PRODUCT / PROCESS CHANGE NOTIFICATION

1.1 Company		STMicroelectronics International N.V
1.2 PCN No.	ADG/21/13157	
1.3 Title of PCN	HI-QUAD 92 14x20 SLUG UP: New Marking Layout	
1.4 Product Category	see list	
1.5 Issue date	2021-12-15

Title : HQ92L_SLU_New Marking Layout Qualification

Marking Layout - Comparison

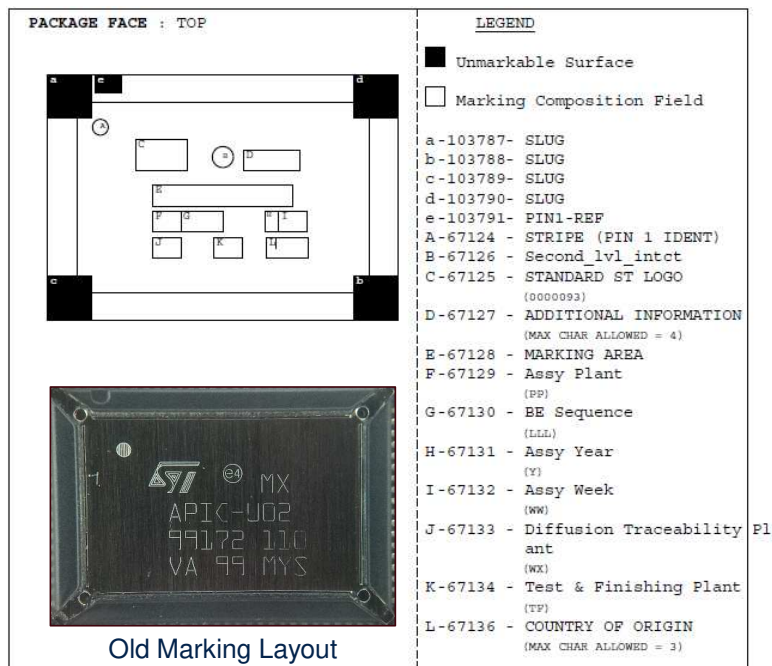
Before : Marking on slug

After : Marking on package

Sample Marking

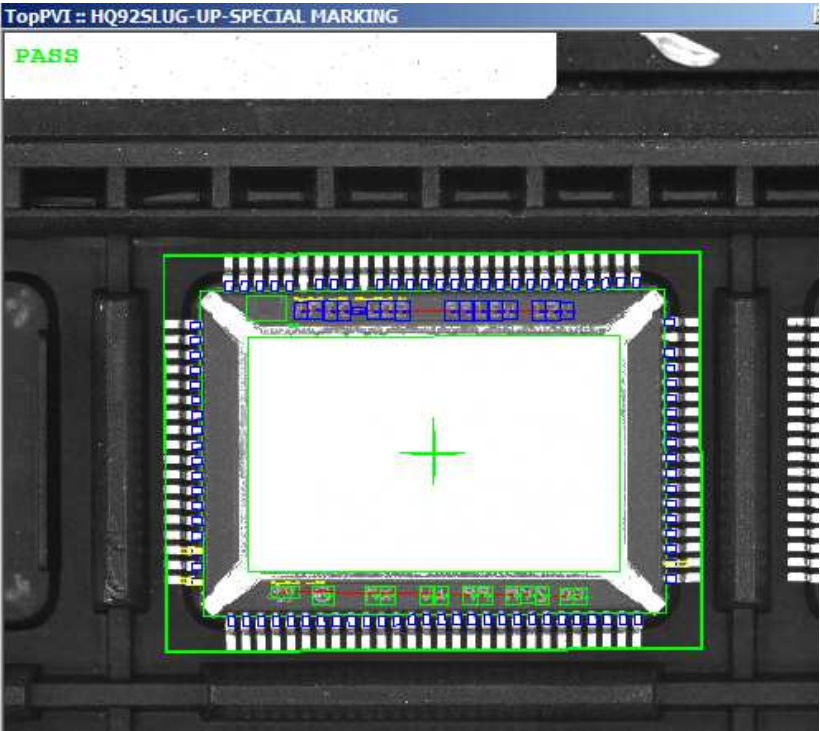
Unit	Marking on package		
	Offset Marking	Illegible Mark	Marking Depth
	Spec: N/A	Spec: N/A	Spec: 6-75um
1	0	0	18
2	0	0	20
3	0	0	23
4	0	0	21
5	0	0	25
6	0	0	20
7	0	0	23
8	0	0	19
9	0	0	20
10	0	0	20
11	0	0	18
12	0	0	23
13	0	0	18
14	0	0	20
15	0	0	18
16	0	0	22
17	0	0	25
18	0	0	20

Min: 18
Max: 25
Average: 20.72
Cpk: 1.76

Sample Marking

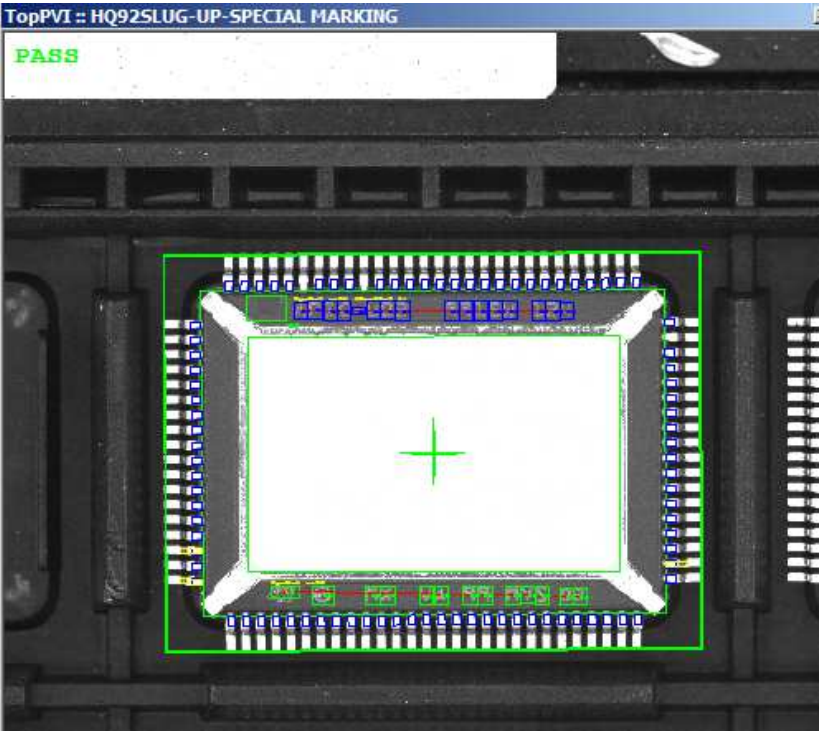
Unit	Marking on package		
	Offset Marking	Illegible Mark	Marking Depth
	Spec: N/A	Spec: N/A	Spec: 6-75um
1	0	0	19
2	0	0	22
3	0	0	23
4	0	0	22
5	0	0	22
6	0	0	20
7	0	0	23
8	0	0	19
9	0	0	20
10	0	0	20
11	0	0	19
12	0	0	27
13	0	0	18
14	0	0	20
15	0	0	18
16	0	0	22
17	0	0	21
18	0	0	20

Min: 18
Max: 27
Average: 20.83
Cpk: 1.81

Sample Marking

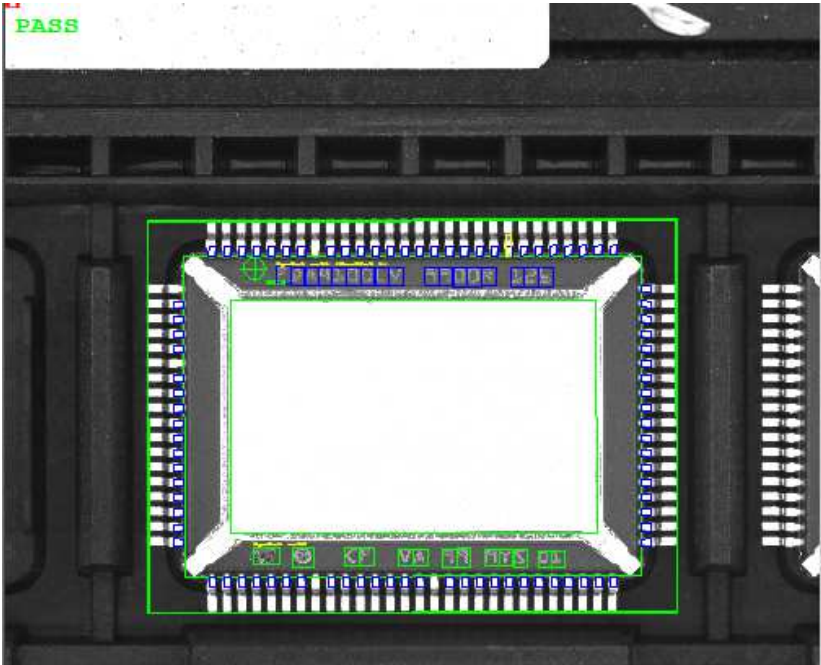
Unit	Marking on package		
	Offset Marking	Illegible Mark	Marking Depth
	Spec: N/A	Spec: N/A	Spec: 6-75um
1	0	0	15
2	0	0	24
3	0	0	22
4	0	0	19
5	0	0	19
6	0	0	25
7	0	0	17
8	0	0	19
9	0	0	17
10	0	0	18
11	0	0	19
12	0	0	17
13	0	0	21
14	0	0	21
15	0	0	20
16	0	0	20
17	0	0	20
18	0	0	21

Min: 15.0
Max: 25.0
Average: 19.6
Cpk: 1.79

Sample Marking

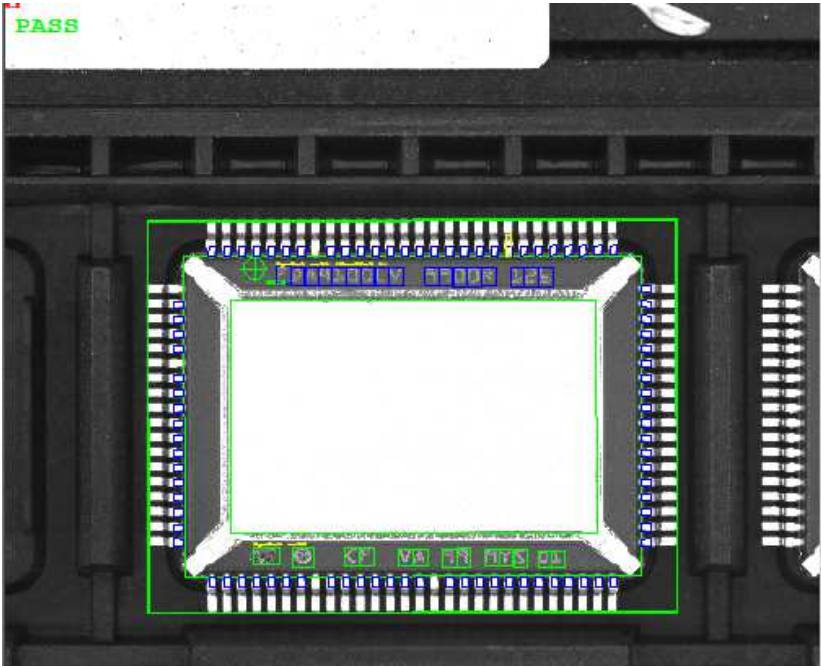
Unit	Marking on package		
	Offset Marking	Illegible Mark	Marking Depth
	Spec: N/A	Spec: N/A	Spec: 6-75um
1	0	0	23
2	0	0	24
3	0	0	22
4	0	0	19
5	0	0	18
6	0	0	18
7	0	0	17
8	0	0	19
9	0	0	17
10	0	0	18
11	0	0	19
12	0	0	17
13	0	0	21
14	0	0	21
15	0	0	20
16	0	0	20
17	0	0	22
18	0	0	22

Min: 17.2
Max: 24.4
Average: 19.6
Cpk: 2.11
